Auckland Council Model Review

Section 3 Review Details

Appendix - FIGURES

Artistry lane and Swamp Kauri developments:

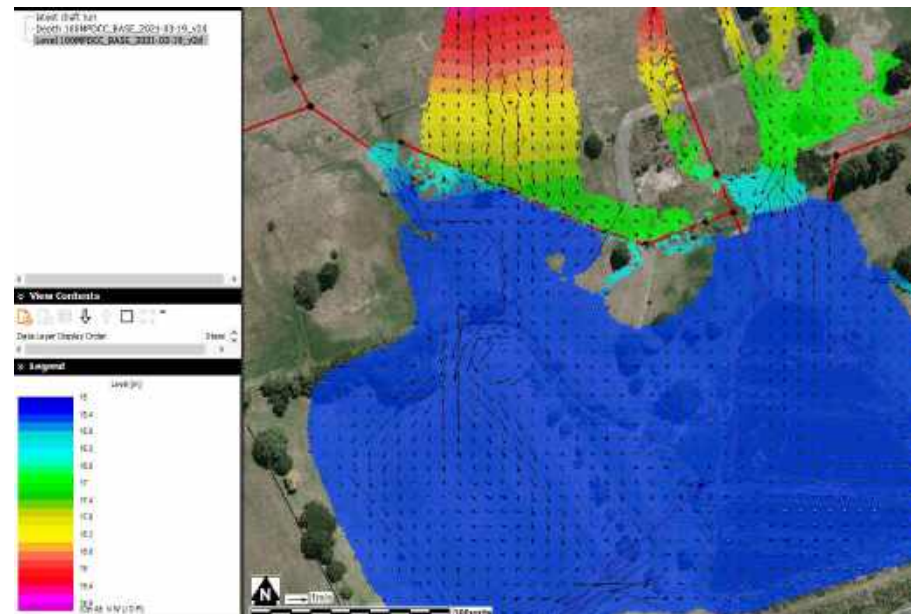
There were significant differences observed at these developments between manhole lid levels and the 2016 LiDAR (the 2016 LiDAR appears to have been captured during earthworks of the development). A 2D surface has been created through interpolation of the manhole lid levels as these are more representative of the developed ground level. There are likely to be uncertainties in the overland flowpaths through these areas and it is recommended that the model is updated with surveyed ground levels/new LiDAR when available.

The model results show a sudden drop in terrain and water level at the Swamp Kauri development (area 1 in figures below) where the terrain created from the Lid levels does not tie in well with the LiDAR. The exact slope to the developed ground level is unknown.

UPDATE:

The steep drops between the development DEM's and the LiDAR/2017 survey contours have been smoothed through interpolation between the datasets.

Figure 1

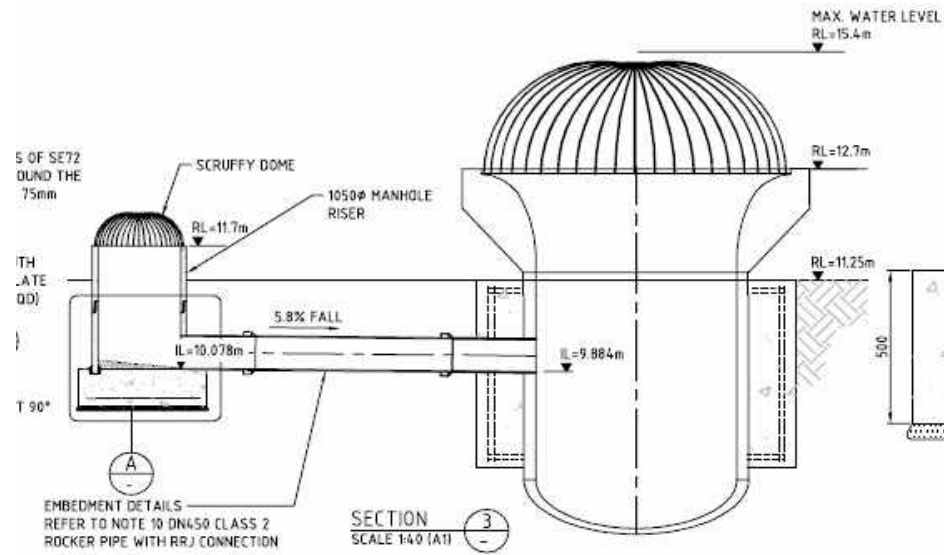
asset data required for culvert/pipe discharging to wetland from Military camp

Appears to be a culvert under Battalion Drive from Military camp to wetland (potentially a private asset). Geomaps shows a 1050 pipe in the vicinity of this area but not clear if this is same asset/latest configuration

Flow from this subcatchment is currently loaded downstream of the asset which is not in the model. Meaning backwater effects through this pipe are not currently included.

UPDATE: Data received and structures have been added to the model
